Ducted Systems Technical Services: YS Letter

Letter: YS-006-21

Subject: **Reliability of modulating gas valve, factory directive concerning FC6, and change in warranty process regarding Critical Data Sheet requirement**

Product/s: Modulating Gas Furnace

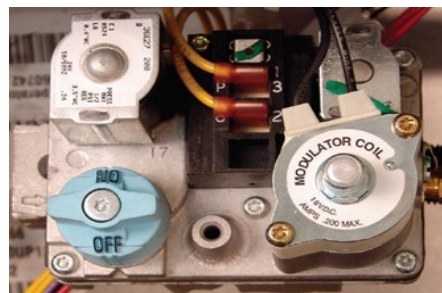
Control Board Software 1180 (Not Covered)

Gen 1 Gas Valve (Not Covered)

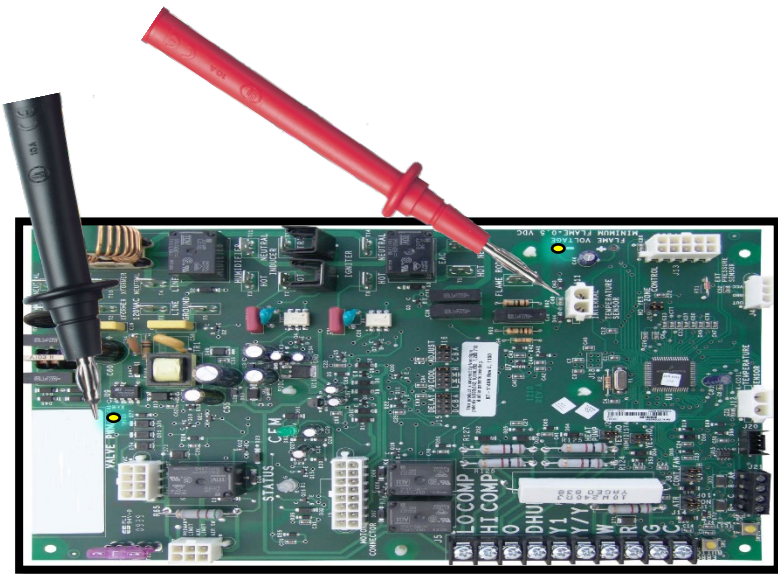
Should Gas Valve replacement be necessary, 1 hour Labor will be provided by filing a standard warranty claim referencing this YS letter and attaching a clear, legible photo of the existing gas valve nomenclature sticker along with dealers invoice to the warranty claim.

NOTE: Inclusion of a **clear legible photo of the gas valve label indicating a Date Code** that is earlier than 1728 (meaning a lower number) eliminates the requirement of filing a Critical Data Sheet with the warranty claim. If a photo and dealer invoice is **not** included with the warranty claim, a correctly filled out Critical Data Sheet is required.
